Dealer4

Firmware Updates Information 12.10.2014

Version 3.06 – published 12.02.2014

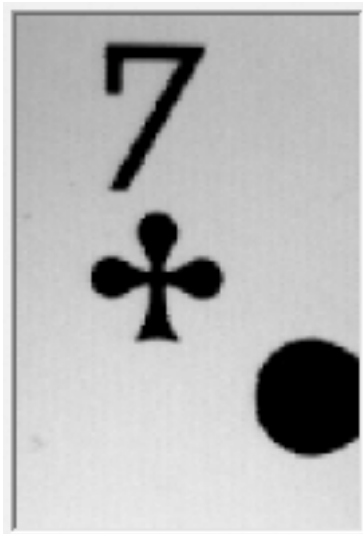
- increased dealing speed (to average 5.4-5.5s)
- improved reading Danish cards
- added special option to recognize cards where the 7 has an elongated top left section as shown below. This option can be enabled by setting **Recognize Option** to 16 in the **Maintenance** screen.

Version 2.90 – published 17.02.2013

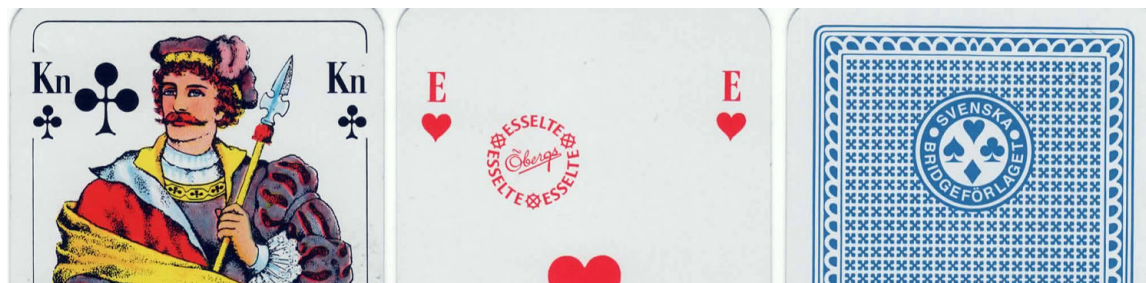
- added recognition for Swedish Svenska Bridgeforlaget cards:

These cards require following settings:

- **Card Index** should be set to **Small**
- **National Settings** should be set to **Swedish**
- **Card Type** should be set to **Standard**
- **Card Font** should be set to **Fine**

Version 2.78 – published 12.07.2012

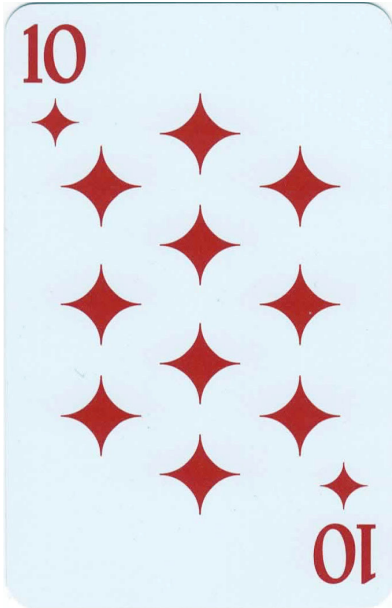
- Corrected a problem with club recognition for Japan Nintendo Cards:

- added recognition of unusual diamond suit shapes for DESJGN cards:

NOTE: these cards require the MAX SYMBOL X value to be changed from the typical 64 to 75.

Version 2.58 – published 16.06.2011

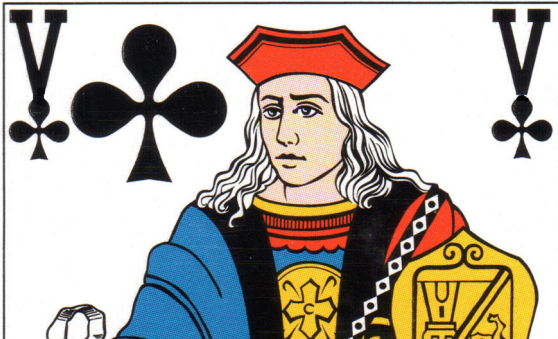
- Improved automatic camera adjustment to make it less sensitive to external light
- Improved recognition of cards with outside frame
- Added recognition of French Bridge Diffusion cards with symbol touching or too close to the suit:
